Certificate of Appropriateness
BAR #25-0099
310 4th Street NE #201, TMP 330205L00
North Downtown ADC District
Owner: Court Square LLC; Great Eastern Management Co.
Applicant: Caitlin Byrd Schafer
Project: Roof over existing patio (north elevation)

**City of Charlottesville
Board of Architectural Review
Staff Report
August 19, 2025**

BAR # 25-0099

Project: Roof over existing patio (north elevation)

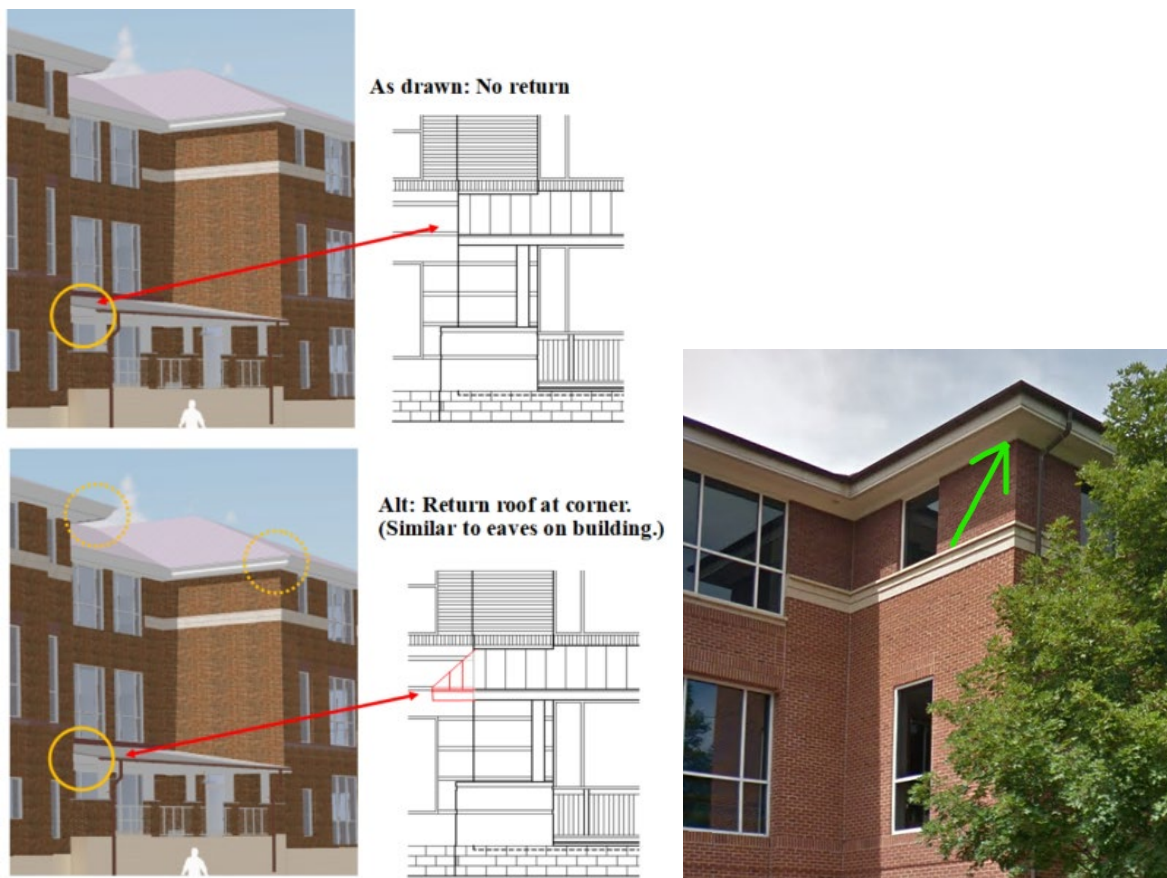
Staff recommends approval of the CoA, with the BAR providing direction on whether the northeast corner of the new roof (see below) should be installed as designed or have a return with an overhanging eave similar to that on the existing building. Staff acknowledges this is not a historic structure; therefore, this is primarily an aesthetic question and not related to a specific provision of the design guidelines. In brief, is the eave detail for this porch roof necessary for the building to remain compatible with the North Downtown ADC District? [See figures next page.]

Having considered the standards set forth within the City Code, including the ADC District Design Guidelines, I move to find the proposed patio roof at 310 4th Street NE satisfies the BAR's criteria and is compatible with this property and other properties in this ADC District, and that the BAR approves the application as submitted.
